Errata Sheet of Rev. B PIC16C62 Silicon

The PIC16C62 (Rev. B) parts you have received conform functionally to the upcoming PIC16C6X preliminary data sheet (DS30234B), except for the anomalies described below.

In the PIC16C6X Preliminary Data Sheet (document DS30234B), the following clarifications and corrections should be noted.

FIGURE 0-1: NEW SSOP PIN-OUT

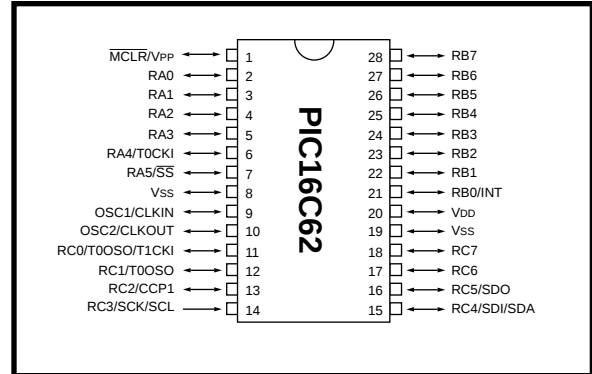
3. In the PIC16C62 Product Brief (DS30414A), the pin-out of the SSOP package is wrong. The correct pin-out is shown in Figure 0-1.
